AEROSTAR SERVICE LETTER 103

11/01/90

- Subject:** Springtop paravent modification
- Applicability:** Aerostar RX-7; Date of manufacture from 5/86 to 11/90.
Aerostar RX-8; All models manufactured before 11/90.
S55-A, S57-A, S60-A; Date of manufacture from 9/88 to 11/90.

FIGURE

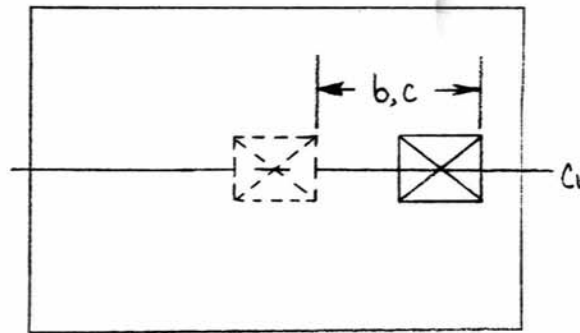
- 1) First, verify that the distance from the box-x (connecting overstrap to top-cap) to the first circumferential "spider web" in the port along the radial measures 24 in. +/- 1 in. (See Fig. 1) If this dimension is not met, the balloon is not affected by this service letter.

- 3) Carefully remove the box-x stitching which connects the overstraps to the top-cap.
- 4) Refer to Figure 1. Except for the center (A) reinforcement patch, the box-x is not re-sewn to the middle of the patch, but is offset as shown. The object of this offset is to preserve the fullness in the vent area of the top-cap; thus the patches are moved towards the center of the vent. Identify each patch as (A), (B), or (C) and mark the offset on the patch.

- 2) Measure three inches radially outward (towards the port edge) from the box-x location on the overstrap, and make a mark. (3 locations RX series, 5 locations S series).

- 5) Using a single needle machine with "F" thread, (6-9 stitches/in., thread type V-T-285 polyester, Type I or II, Class 1 or 3), sew a box-x connecting the top-cap to the overstrap at the marked locations.
